LAKE HAVASU CITY, ARIZONA

ADDENDUM NO. 2

Site Six Boat Ramp Replacement

Project No: B24-PW-500411

2 RAMP SUBGRADE DETAIL
SCALE: 3" = 1'-0"

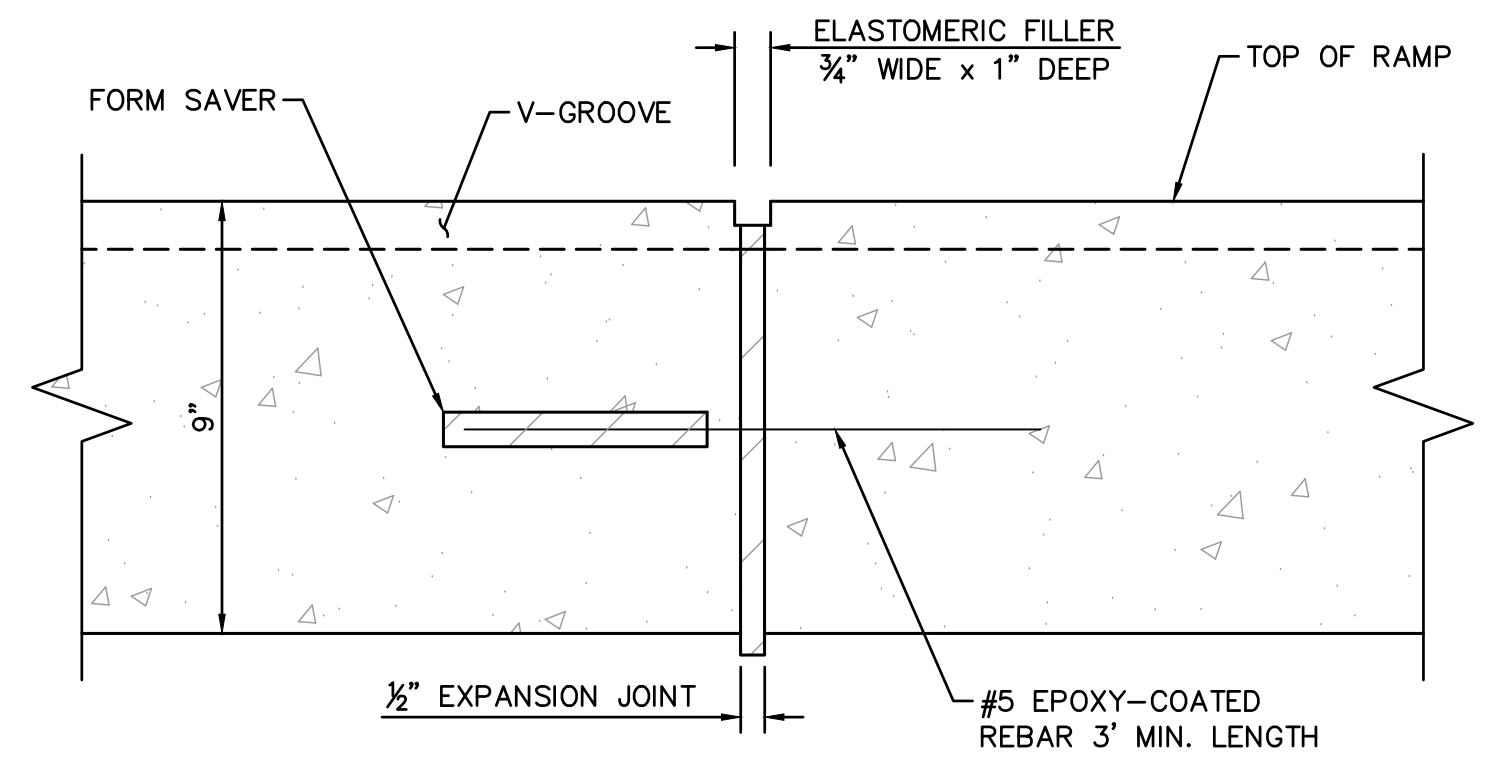
4. Refer to detail 2 on drawing ST03 issued as part of this addendum 2. Please confirm the spec on the sand. I assume this detail is to be used for the reinforced concrete slab only. This detail is not referenced anywhere on the drawings. Please confirm.
DETAIL 2 ON THE DRAWING ST03 IS TO BE USED AT THE REINFORCED CONCRETE RAMP. THIS DETAIL SHOULD BE USED IN CONJUNCTION WITH CONSTRUCTION NOTE 1 ON SHEET ST01. SECTION FOR RAMP SUBGRADE DETAIL IS UPDATED. SEE ATTACHED REVISION.

NO.	REVISIONS / SUBMISSIONS	DATE
1	RAMP SUBGRADE UPDATES	9/20/23
